KANSAS CITY AREA TRANSPORTATION AUTHORITY

Invitation for Bids (IFB) #F23-5001-39A  
112 Tram Rail Expansion Joints

ADDENDUM #2

Issue Date: December 28, 2022

RAIL EXPANSION JOINT DETAIL  
NOT TO SCALE

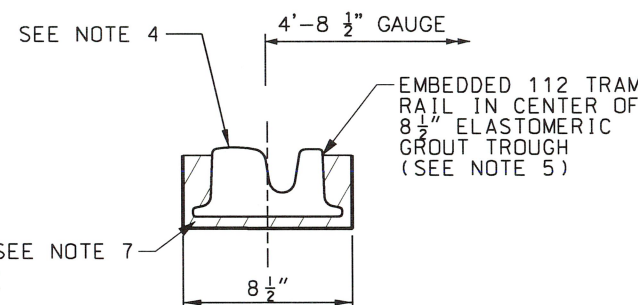
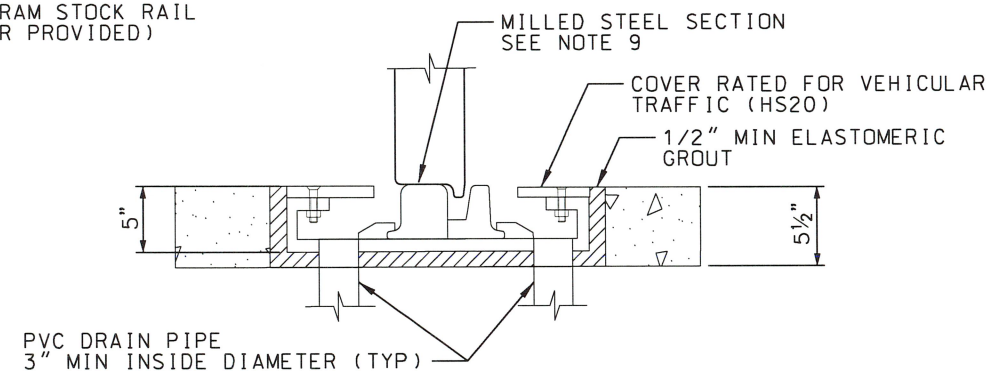
1. Q: 112 TRAM rail expansion joint drawing K922 section C-C shows milled AS400 steel section, is this material astralloy? If not, can you please provide more details on this type of steel?

3. Q: Drawing K922 show the enclosure of the expansion joint insulated with 1/2" min elastomeric grout. Would encapsulation of the enclosure with 5/32" thk polyQuik P-480 be acceptable?

A: Steel for the milled section shown in Section C-C shall have a minimum hardness of 350 BHN and shall meet or exceed the requirements outlined in §34 11 00 (included in this addendum)

A: Referencing Sheet K923 that addresses 112 Tram Rail (not K922 that references 115 RE Rail), alternate materials may be accepted, but the encapsulation shall meet the requirements from Section 34 11 93.

- STEEL FOR MILLED SECTION SHALL MEET OR EXCEED THE REQUIREMENTS OUTLINED IN SPECIFICATION SECTION 34 11 00, INCLUDING A MINIMUM HARDNESS OF 350 BHN.
